### STAFF REPORT FOR THE PLANNING COMMISSION

FILE NUMBER:	SUB-17-04  December 20, 2017  Six-lot ELD Subdivision at 4096 Cornwall Street			
MEETING DATE:				
REQUEST:				
APPROVAL CRITERIA:	Community Development Code (CDC) Chapter 11, Single-Family Residential Detached, R-10; Chapter 28, Willamette and Tualatin River Protection; Chapter 48, Access, Egress and Circulation; Chapter 54, Landscaping; Chapter 55, Design Review; Chapter 85 Land Division General Provisions; Chapter 92, Required Improvements; ORS 197.360 to 197.380			
STAFF REPORT	September 10 Company of the Company			
PREPARED BY:	Jennifer Arnold, Associate Planner			
Planning Manager's	Initials Development Review Engineer's Initials			
	TABLE OF CONTENTS			
STAFF ANALYSIS AND REC	COMMENDATION			
GENERAL INFORMATION				
EXECUTIVE SUMMARY2-3				
SITE CONDITIONS				
PUBLIC COMMENTS				
RECOMMENDATION				
	ADDENDUM			
APPLICABLE REGULATION	S AND ASSOCIATED SUPPLEMENTAL FINDINGS			
EXHIBITS

# PRELIMINARY STREET PROFILE

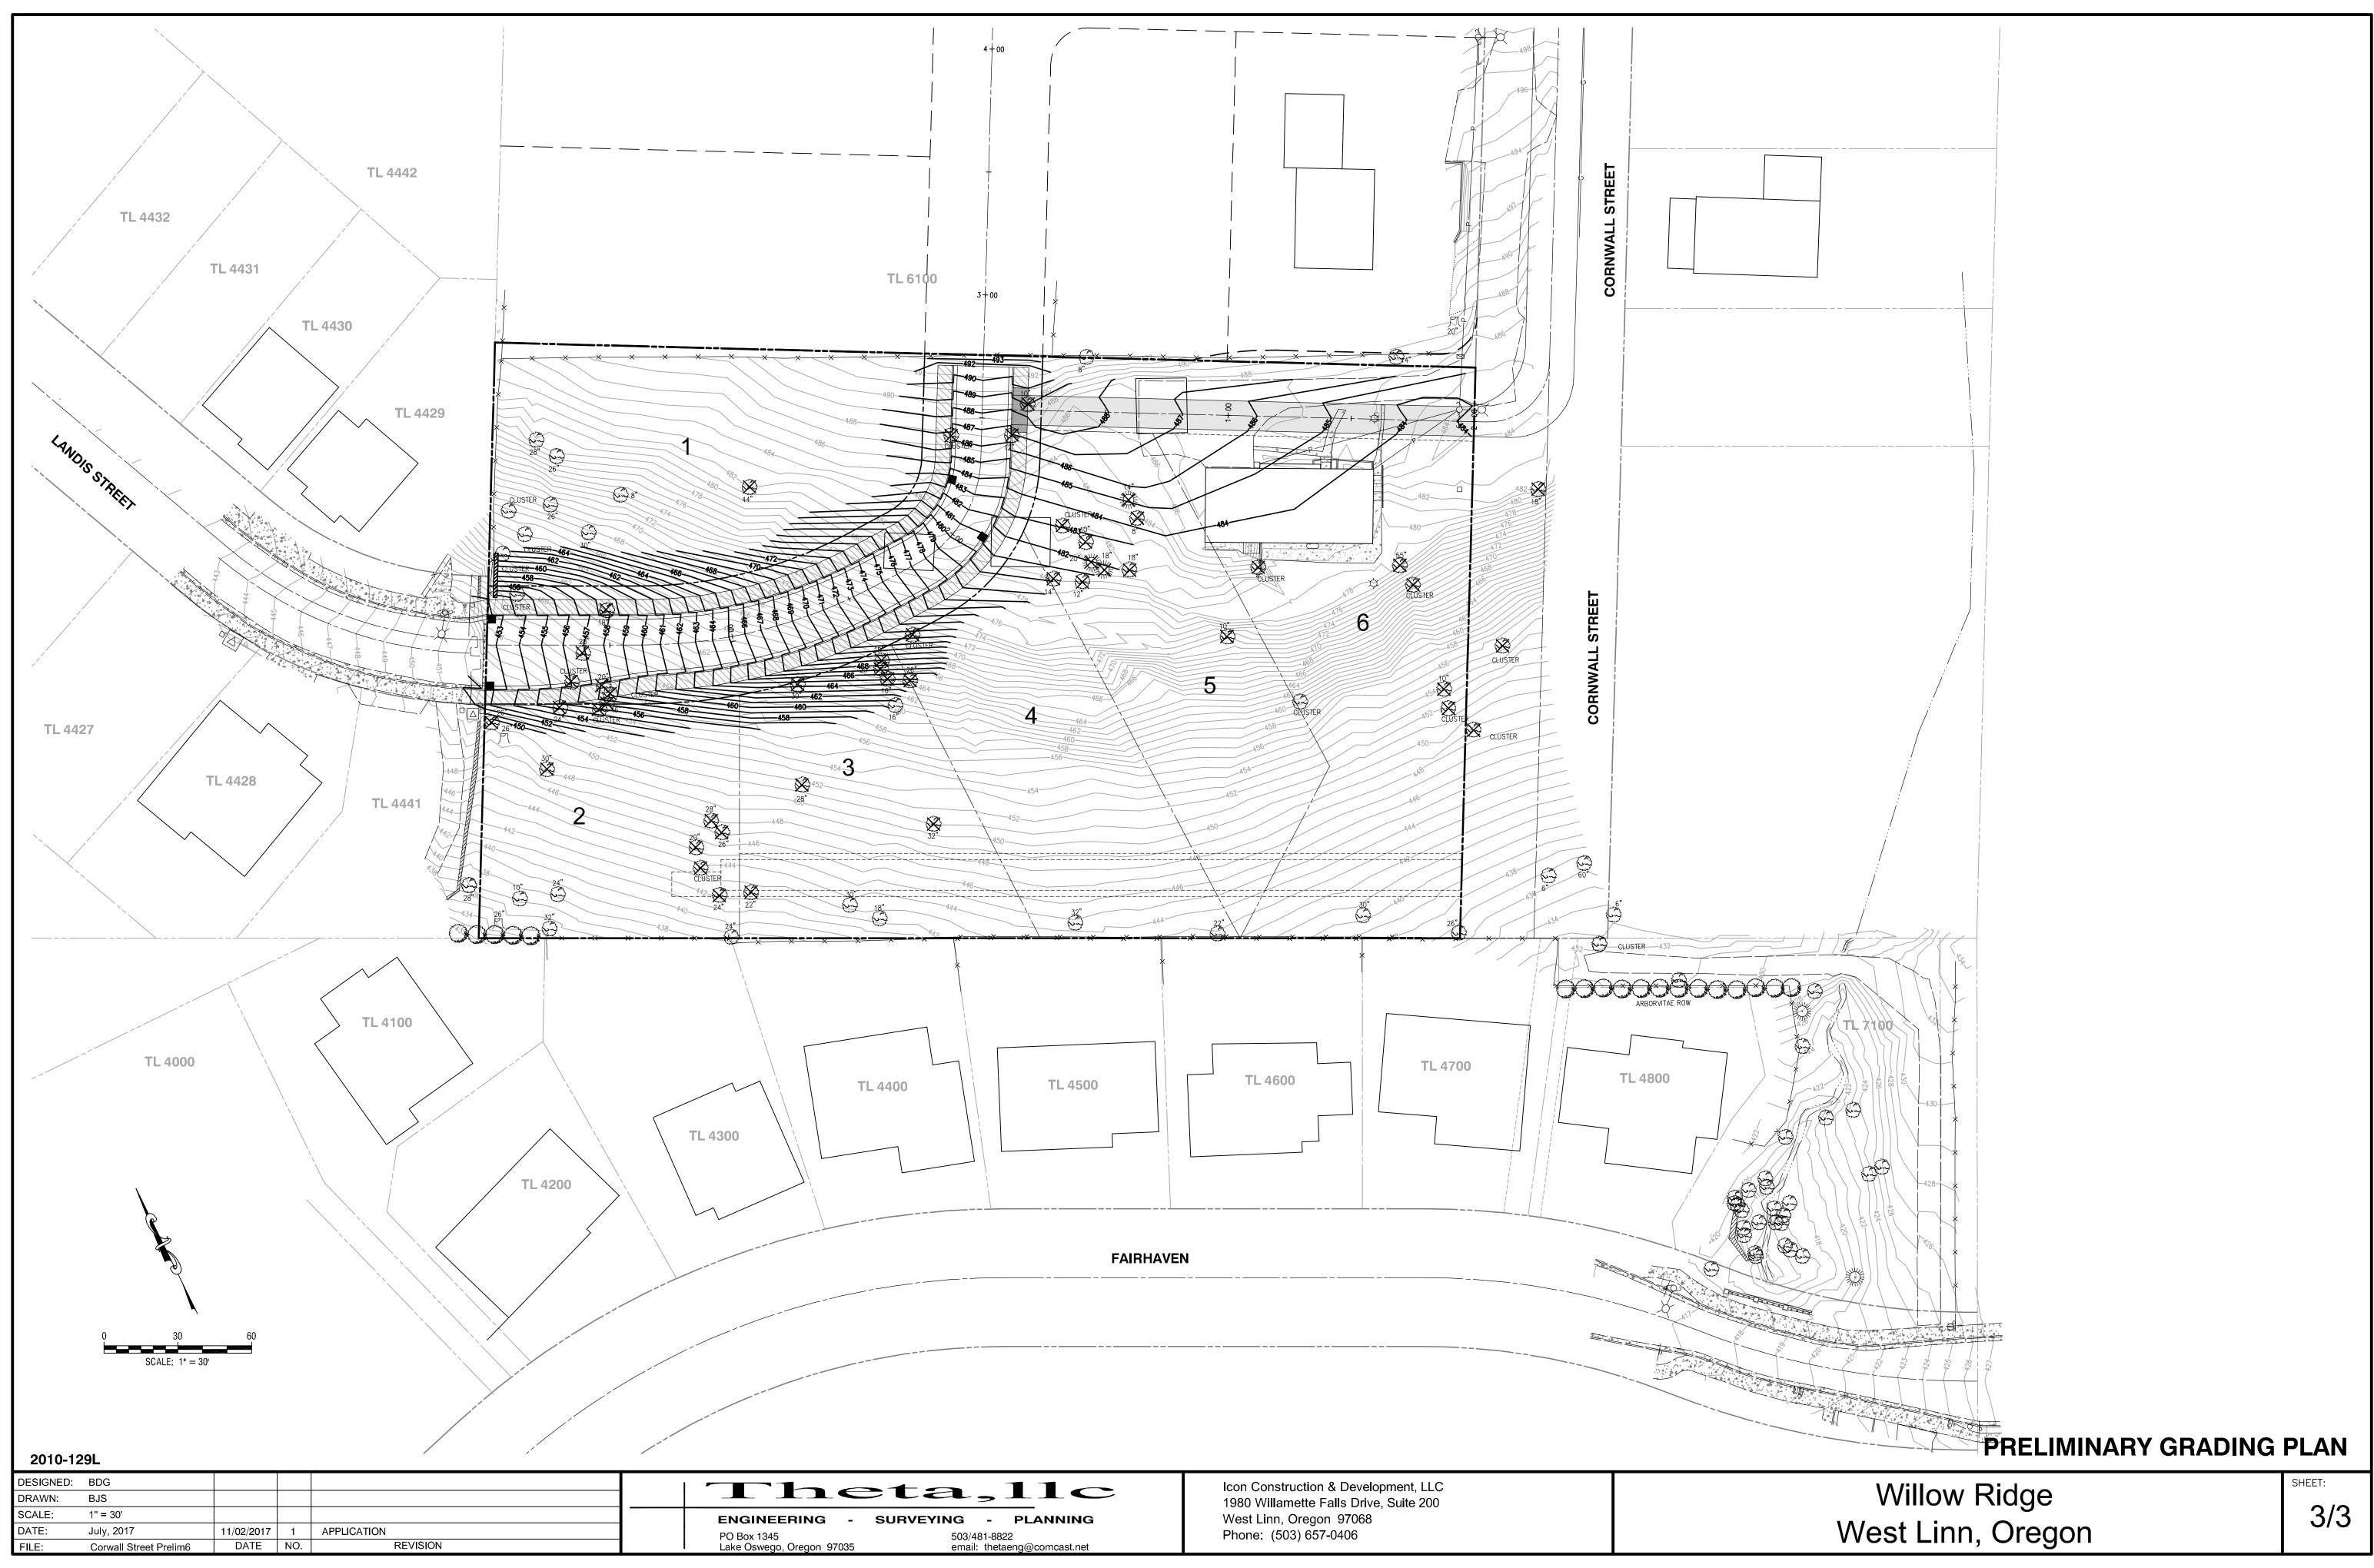
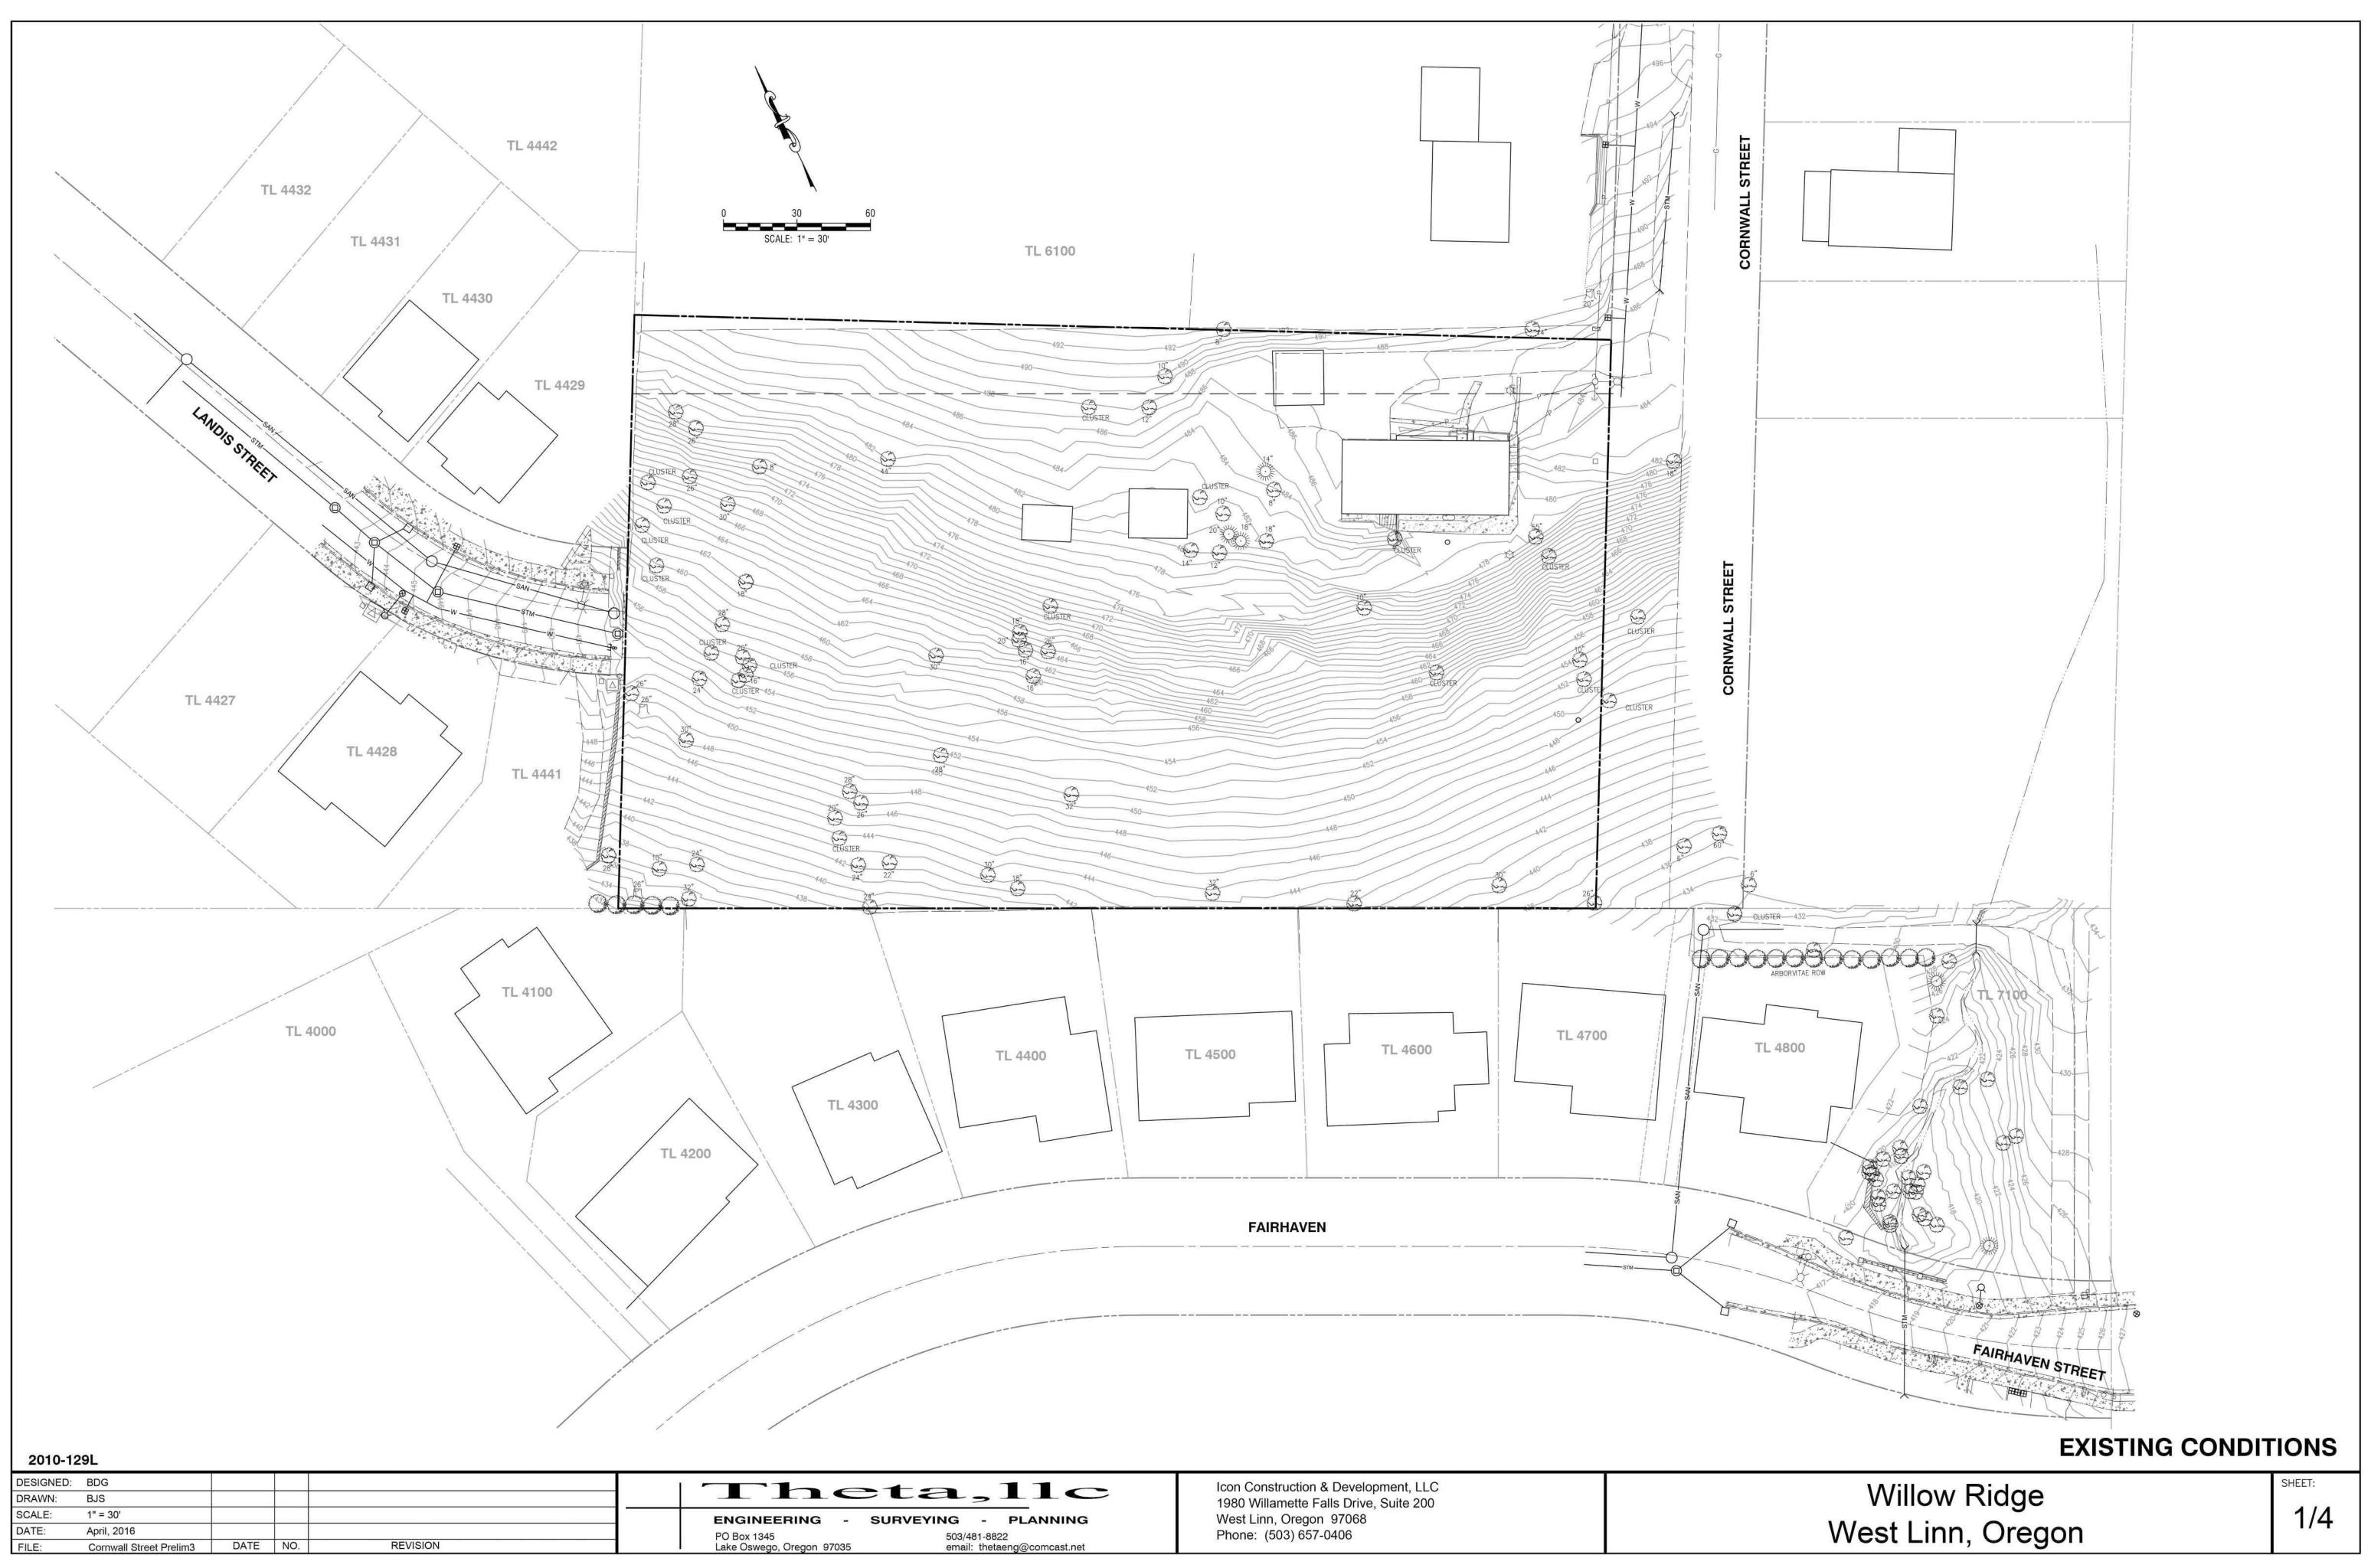
Staff Finding 24: The "Preliminary Street and Utility Plan" (Sheet 1/3) proposes a storm sewer line and sanitary sewer main along the rear yards of Lot #2-6, within the significant tree protection area discussed in the written application. These utilities and easements shall be moved out of the tree protection area per condition of approval 4 Subject to the approval of the Staff recommended conditions of approval, these criteria could be met.
